Work Order ID 135097

Item Name: Crosstube Turning Detail

DRAWING NO. D206-667-141	TITLE CROSSTUBE ASS'Y (206B HIGH FWD)	REV. C	DART AEROSPACE LTD ENGINEERING ORDER		D.E.O. NO. D206-667-141-C-1	SHEET NO. SHEET 1 OF 1	SCALE NTS
DRAWN <i>Q</i>	CHECKED <i>ASS</i>	MFG. APPR. <i>JD</i>	APPROVED <i>MD</i>		DE APPR. <i>HA</i>		
DATE 11.07.15	DATE 11.07.20	DATE 11.07.21	DATE 11/07/21		DATE 11.07.21

DRAWING NO. D206-667-141	TITLE CROSSTUBE ASS'Y (206B HIGH FWD)	REV. C	DART AEROSPACE LTD ENGINEERING ORDER		D.E.O. NO. D206-667-141-C-2	SHEET NO. SHEET 1 OF 1	SCALE NTS
DRAWN AJS	CHECKED <i>[Signature]</i>	MFG. APPR. <i>[Signature]</i>	APPROVED <i>[Signature]</i>		DE APPR. <i>[Signature]</i>		
DATE 12.08.02	DATE 12.08.02	DATE 12.08.02	DATE 12.08.02		DATE 12.08.02

DETAIL P
BONDING STRAP INSTALLATION-2-PL

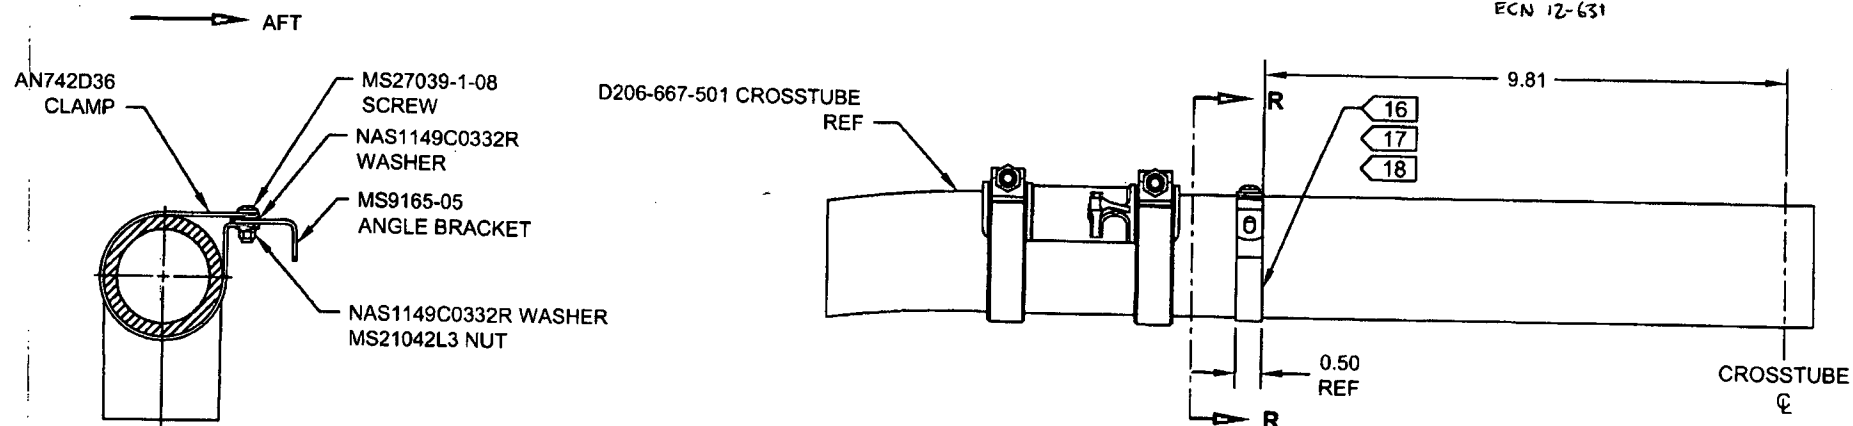
ADD ELECTRICAL GROUNDING STRAP

ITEM	QTY -141	PART NUMBER	DESCRIPTION
1	X	D206-667-141	CROSSTUBE ASSEMBLY (206B HIGH FWD)
<i>[Lightning Bolt Symbol]</i>			
10	2	AN742D36	CLAMP
11	2	MS9165-05	ANGLE BRACKET
12	2	MS21042L3	NUT (OR MS21042-3)
13	2	MS27039-1-08	SCREW
14	4	NAS1149C0332R	WASHER (OR AN960C10L)

- 16) MASK AREA UNDER CLAMP PRIOR TO PAINTING
- 17) SEAL EDGES WHERE AN742D36 CLAMP MEETS WITH THE CROSSTUBE USING SIKAFLEX-241/-291 OR MIL-S-8802 CLASS B2 OR PROSEAL 890 SEALANT
- 18) PERFORM RESISTANCE CHECK TO ENSURE MAX RESISTANCE IS 10 MILLIOHMS
